Planning Board AGENDA

Thursday, June 4, 2026 - 6:00 PM

- 1) 6:00PM Public Hearing-Zone Change Request-430 North West Street-Chanda Care, Inc.
- 2) Site Plan-233 Main Street-HP Hood, LLC.
- 3) Site Plan-195 South Westfield Street-Aljanabi
- 4) Site Plan-73 Garden Street-Juniors Towing
- 5) Form A-130 South Westfield Street-Tirone
- 6) Sign Plans , Performance Agreement, & Covenant-High Street Subdivision-Calabrese Construction, LLC
- 7) Approval of Minutes-May 21, 2026
- 8) Correspondences

DRAWING#	REV.
C-3	A

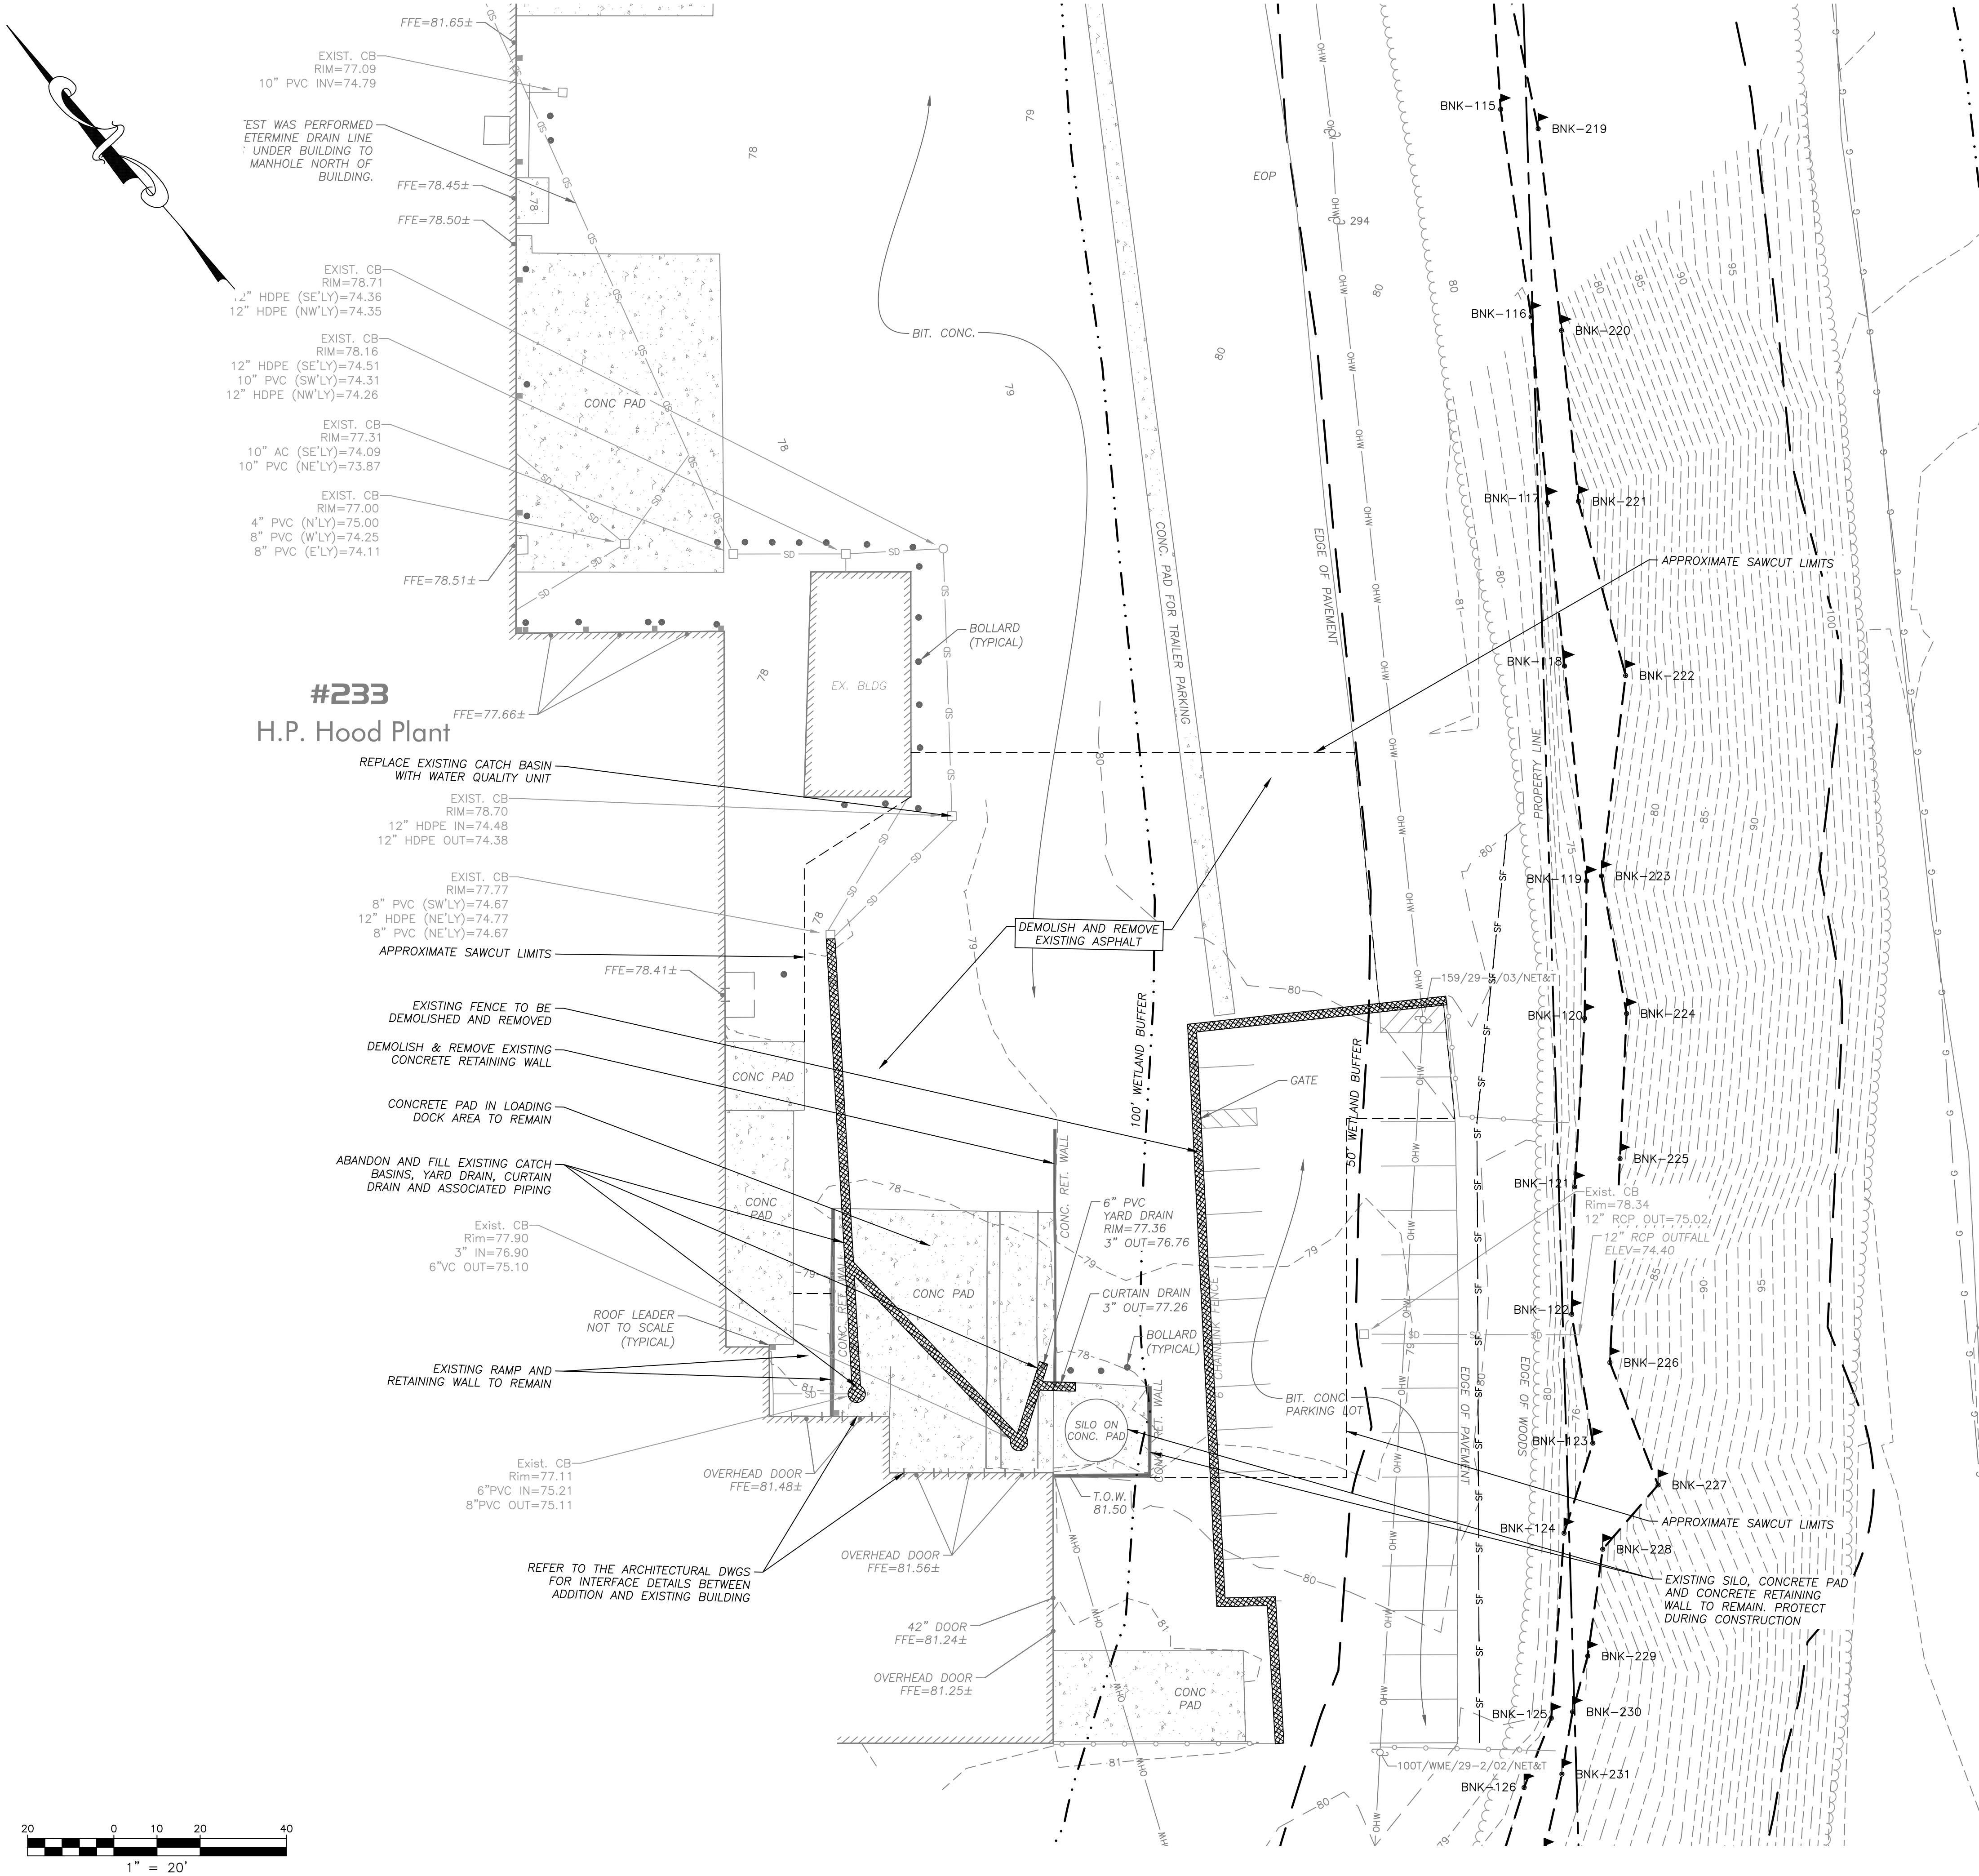
1. There is a callout note on Sheet C-3 of the Site Plans indicating the existing catch basin on the eastern side of the project area will be replaced with a water quality unit. However, a note on Sheet C-5 states the catch basin will remain and a hood will be installed. The Developer will need to clarify if the catch basin is to remain or be replaced.

DRAWING#	REV.
D-1	A

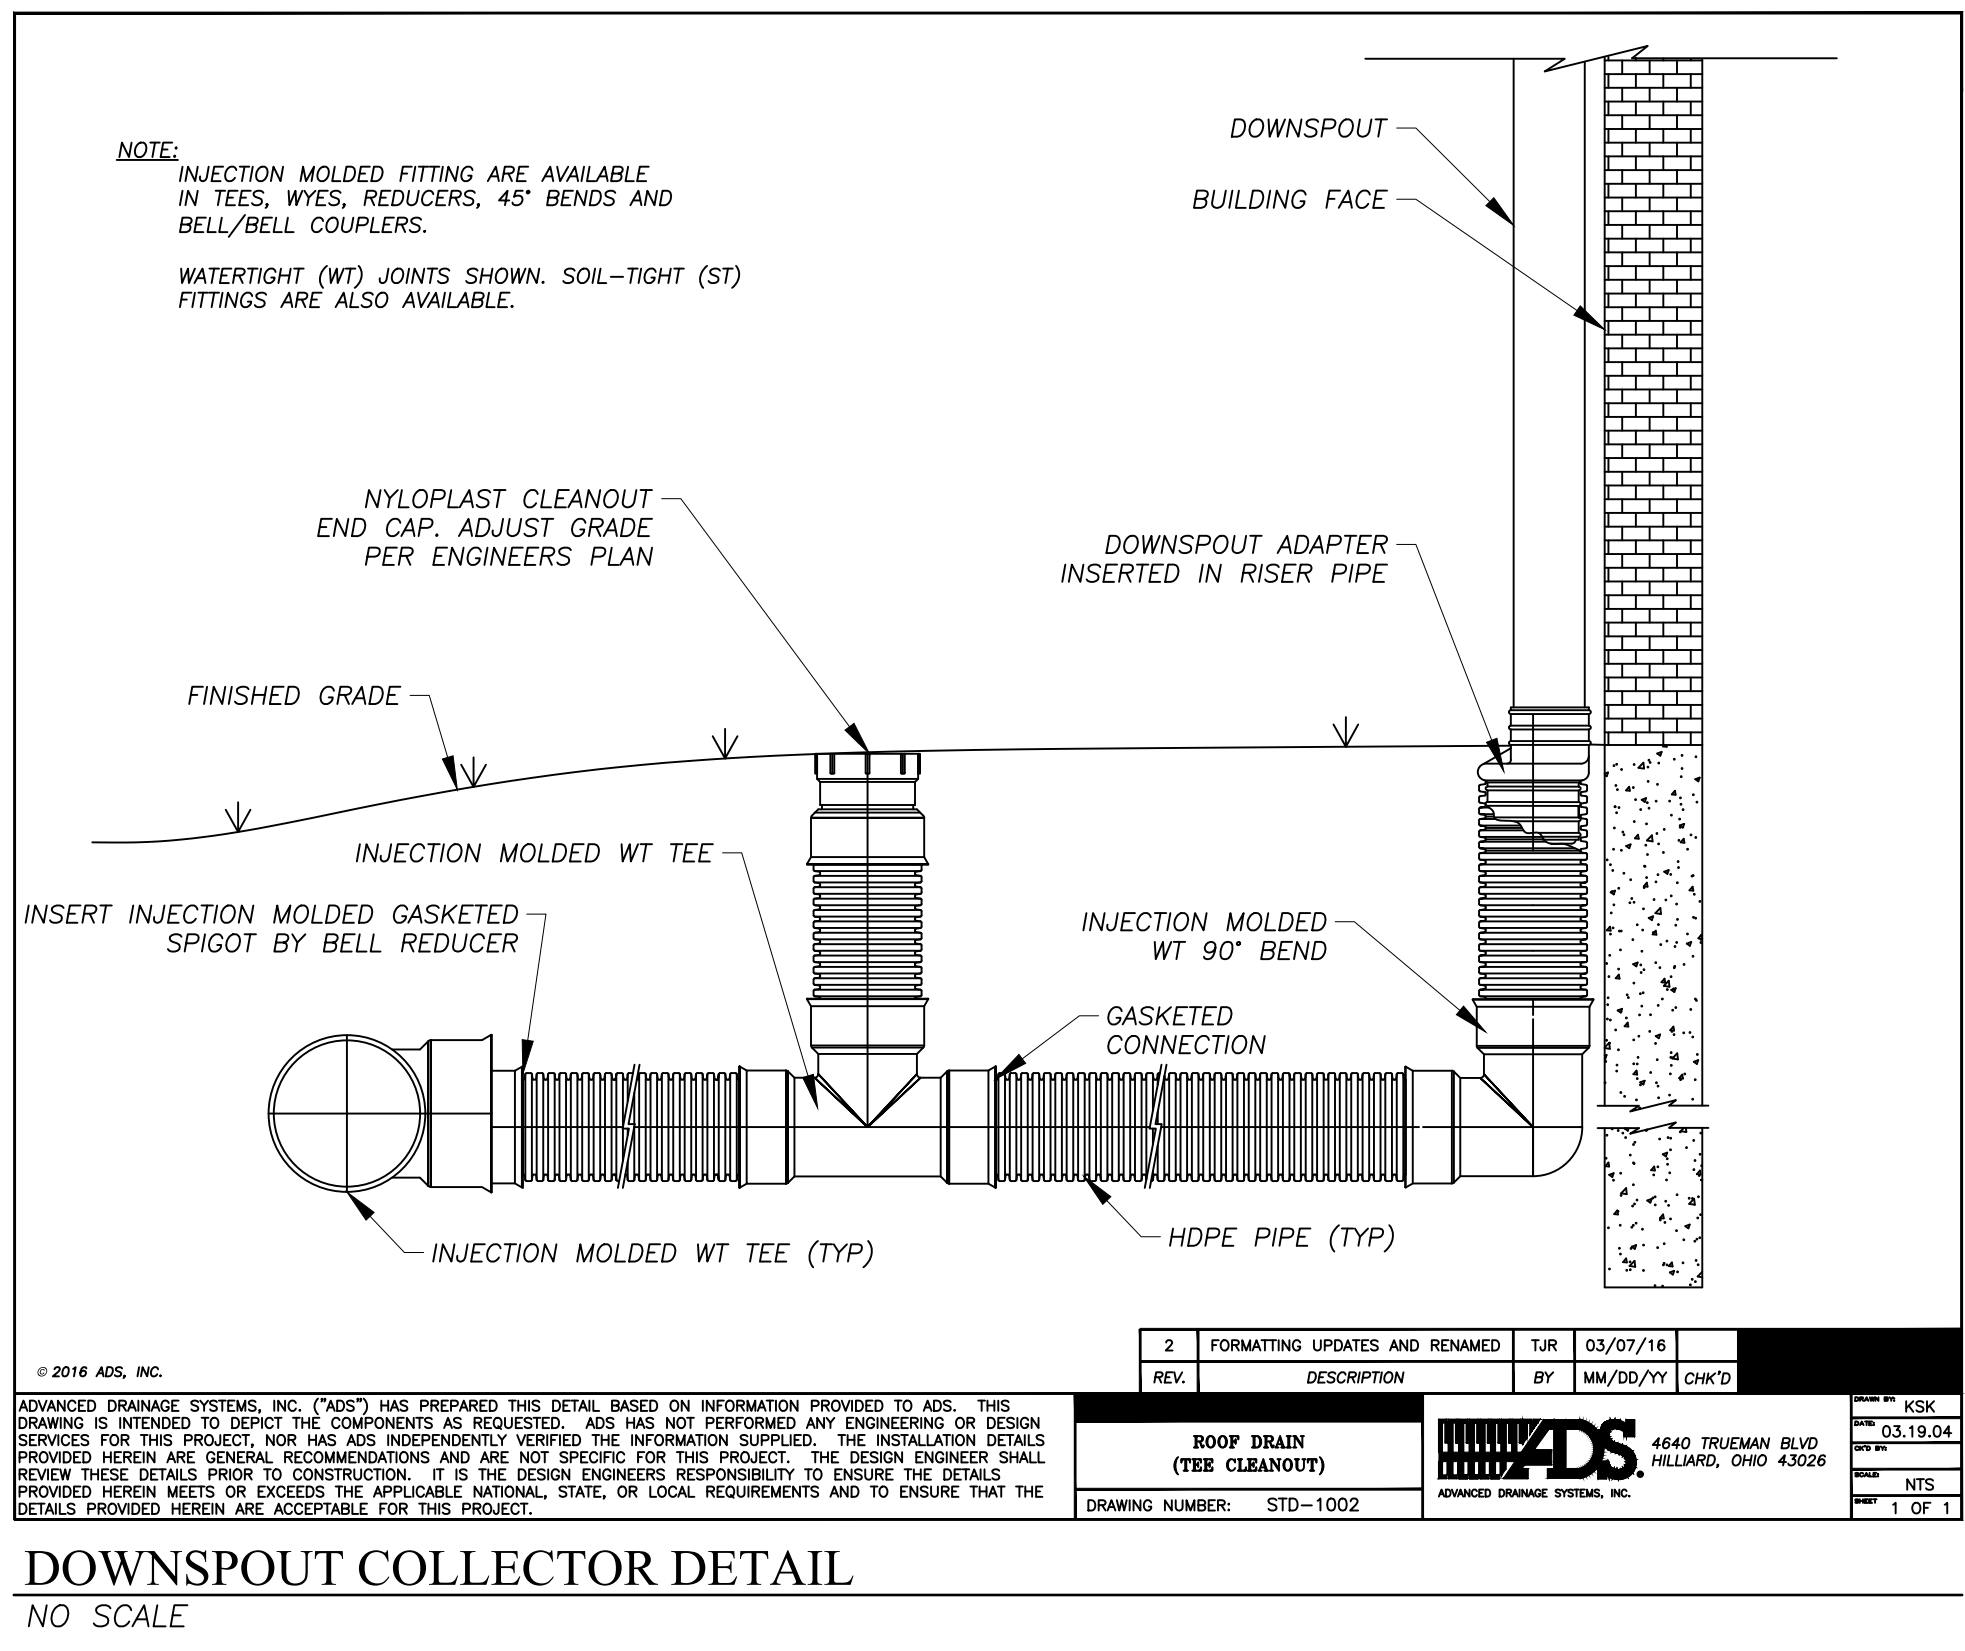
- 10. Engineering request a detail for the PCO(s) to be shown on Sheet D-1.
 - 11. Engineering in requesting clarification on whether parking will be allowed in the area that will not be restriped across from the southeast side of the proposed building addition.
